Job Title
 The Warren
 8 Carbone Hill
 Northaw
 Herts EN6 4PL

Drawing Title
 Existing & Proposed Elevations
 & Layout for replacement fence
 & hedge to front boundary

Drawing No
 SP4A

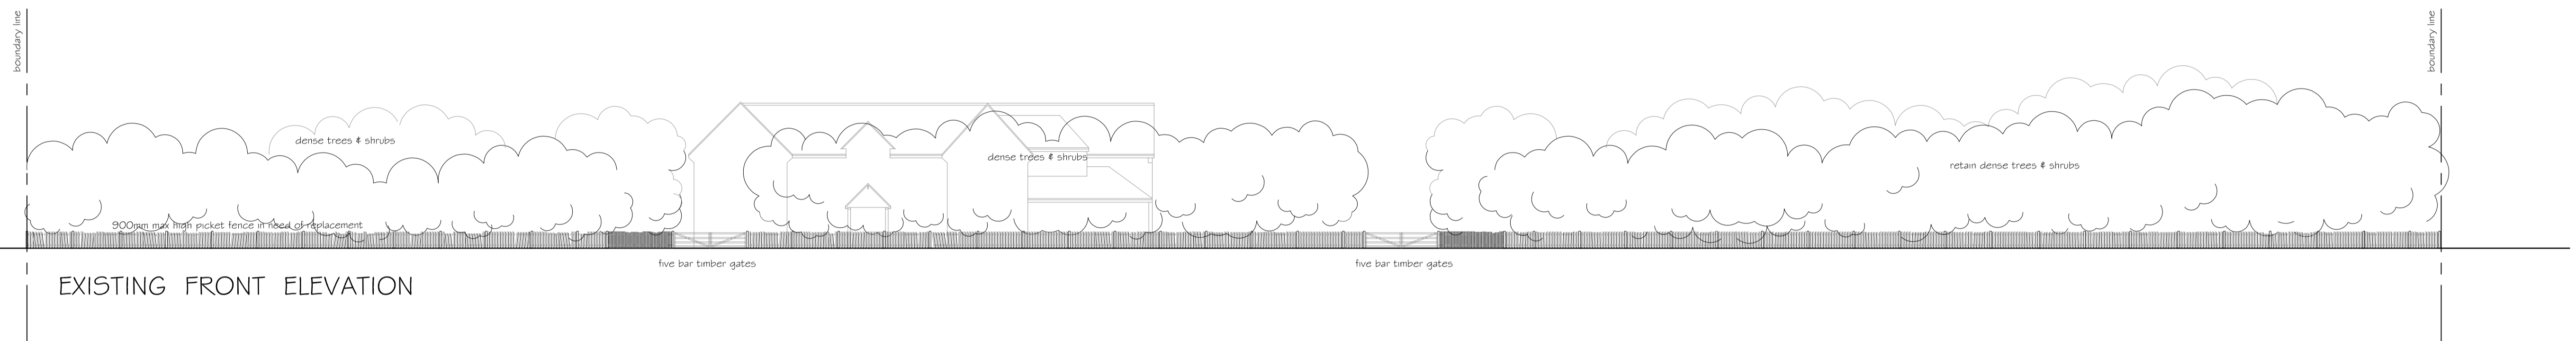
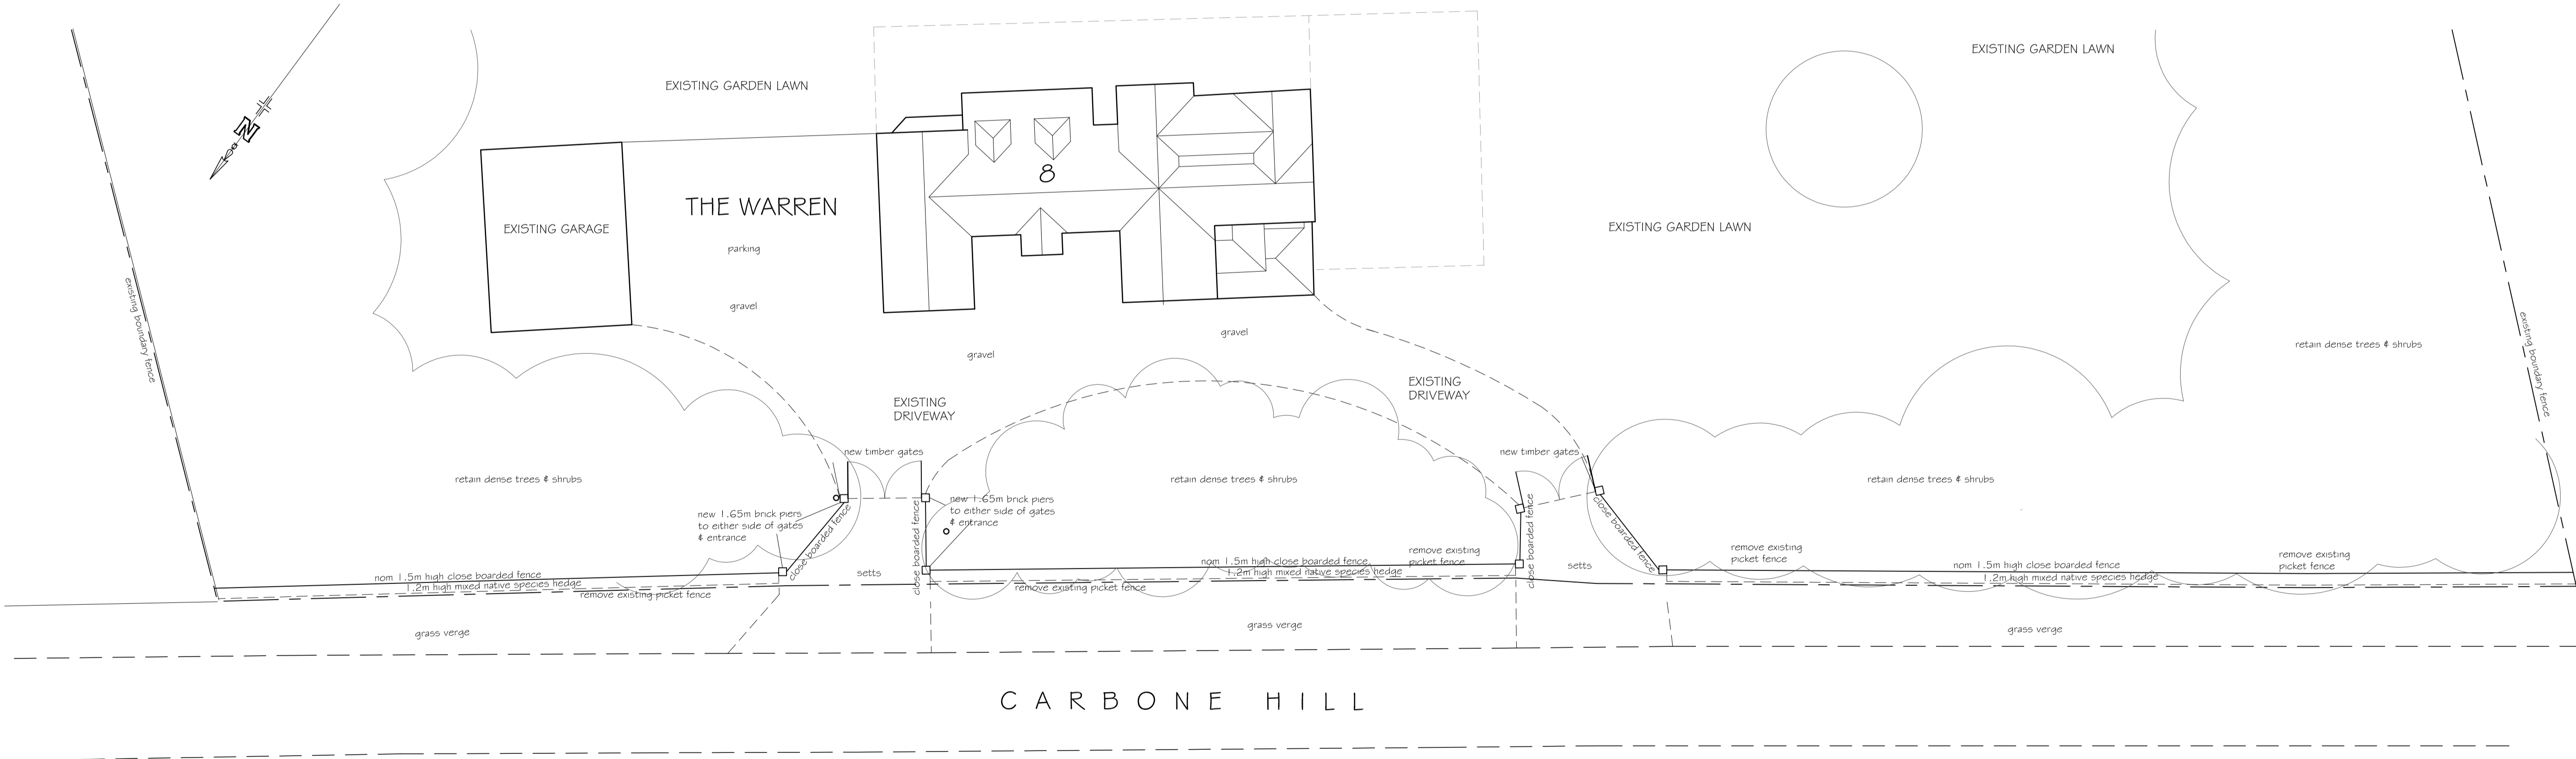
Rev A: Timber gates removed, metal gates added, hedge & fence line revised to suit LPA requirements. February 2019
 Revision Date
